TECHNICAL BULLETIN

Publication No. 14560036 3/10

RCCR RECEIVER SQUELCH BLOCKING

RF BOARD COMPONENT PLACEMENT

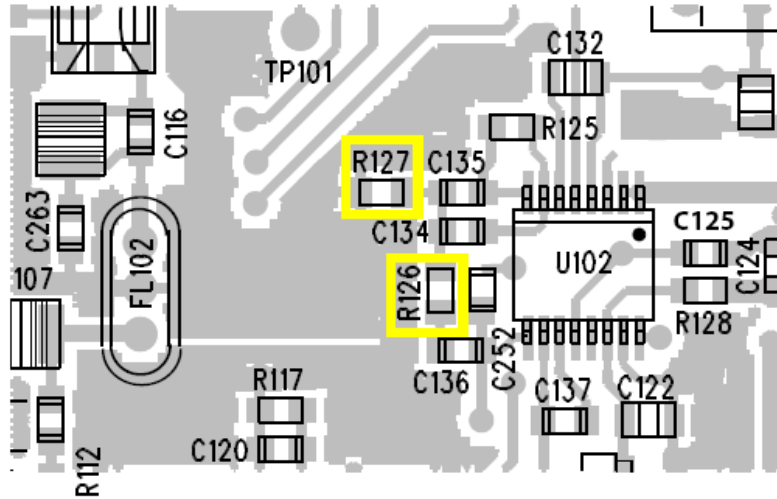
- Modifications:** On the 9/RCCR-RF board, under the top cover, change R127 from a 1.5k Ω 0603 resistor to a 1.0k Ω 0603 resistor. This change increases the center frequency of the squelch noise filter from 3.6 kHz to 4.4 kHz so that voice audio does not affect the level of squelch noise.

Change R126 from a 180 k Ω 0603 resistor to a 220 k Ω 0603 resistor. This change will increase the dynamic range of the noise squelch at 12 dB SINAD levels.
- Notes:** After the modifications are completed, all squelch settings should be re-adjusted, using the Align Section of the RCCR PC Programmer.
